# **Coupling a three-dimensional subsurface flow and transport model with a land surface model to simulate stream-aquifer-land interactions (CPv1.0) [MS No.: gmd-2017-35]**

## **Responses to review comments**

### **Anonymous Referee #2**

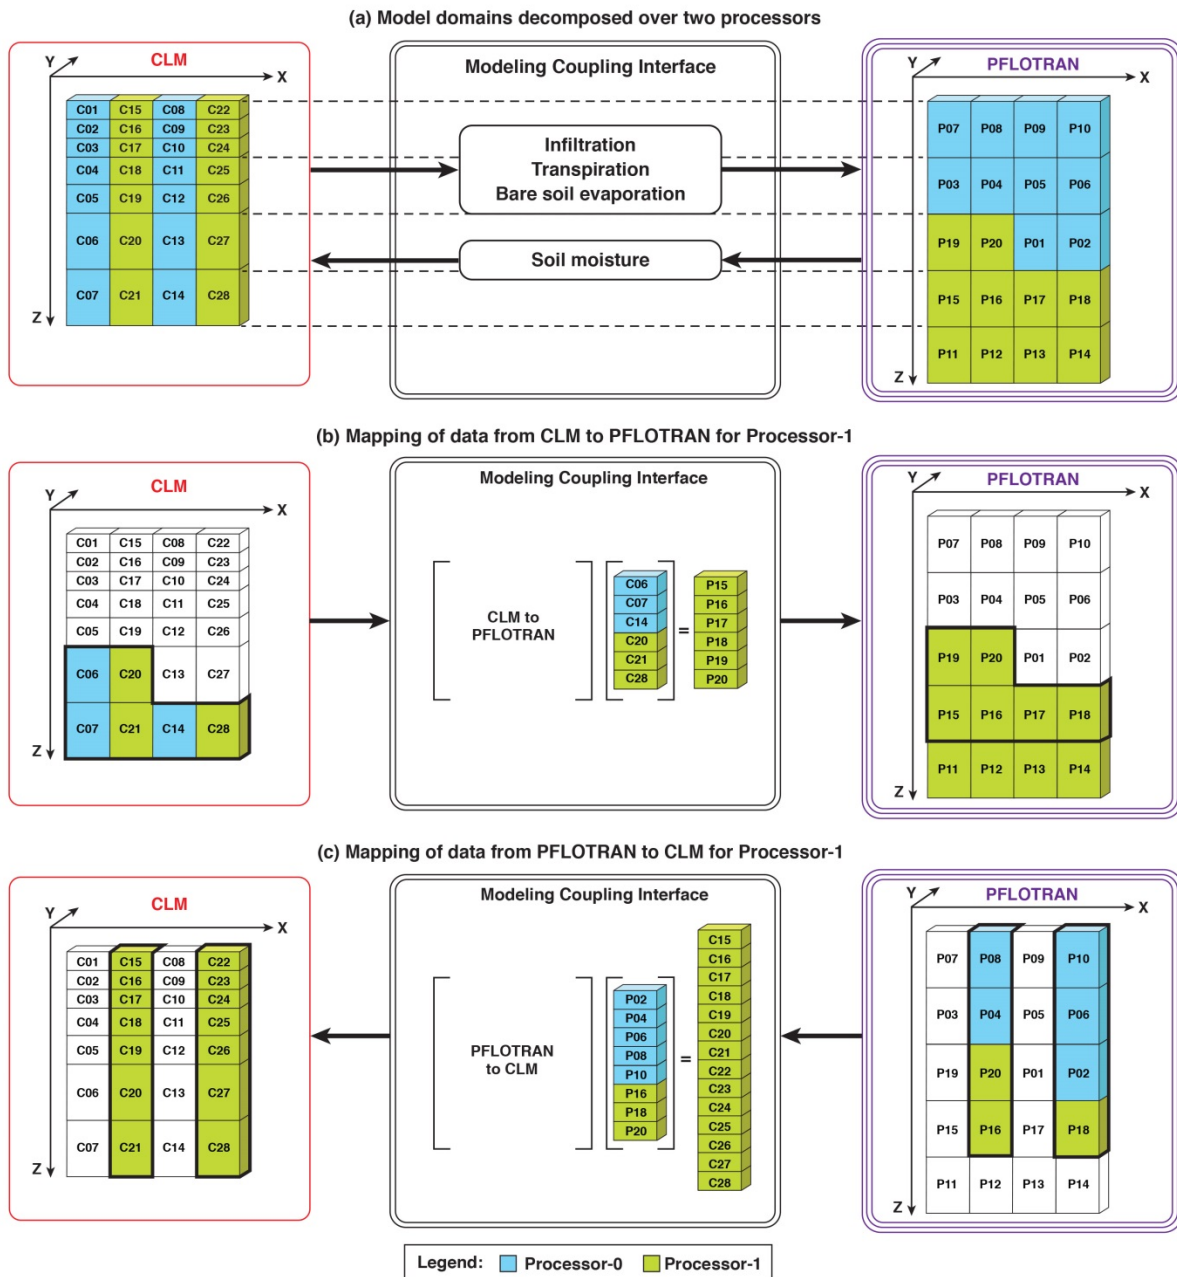
6. *Lines 205-220. As I see it, the coupler is the only potential contribution made in this work. The description needs to be much more detailed. What fluxes and states are passed between the two codes? How is the gridding handled? How is the parallelization accomplished for tiling in CLM and cells in PFLOTRAN? How is the grid overlap between soil column and 3D mesh approached, is the 3D Richards' formulation used in place of CLM or is there some other point where the codes couple? What time integration strategy is used? These are all critical points that should be addressed.*

**Response:** In response to all reviewers' comment regarding model coupling, we have significantly revised the technical details about model coupling in Section 2.3 and added a new schematic (Figure 1) to describe the two-way model coupling. We attempted to answer all the specific questions of this comment. The models are coupled two-ways and we have updated Figure 1 to better represent model coupling as follows. Please section 2.3 of the revised manuscript for detailed description on this coupling.
